DWDM SIGNAL_DETECT behavior

Eric Maniloff

Ciena

July 16, 2020

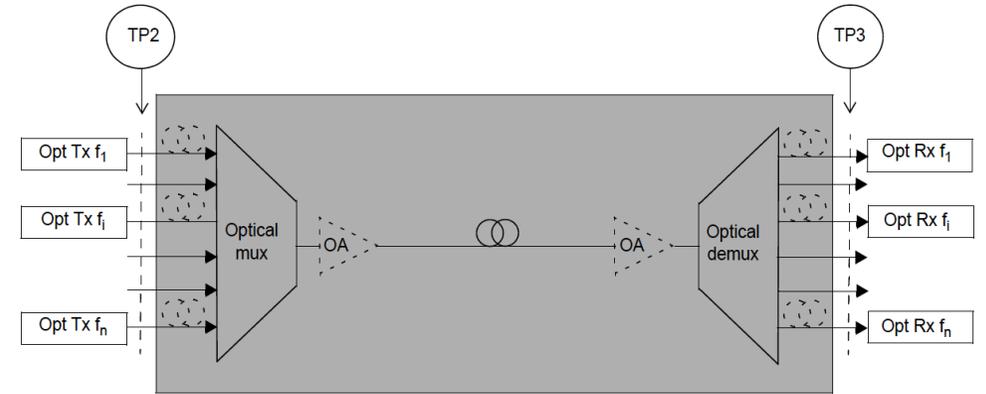
CI 154 SC 154.5.4 P104 L32 # 105

Maniloff, Eric Ciena
 Comment Type T Comment Status D

Rather than Optical Power the Receive Condition should refer to Signal Power

SuggestedRemedy

Change "Average Optical" to "Optical signal"

PROPOSED REJECT.
 The commenter has made insufficiently clear why changing "average optical power" to "optical signal power" resolves the issue, also raised in other comments, on SIGNAL_DETECT and how this would improve the quality of the draft.
 See also resolution to comment #69
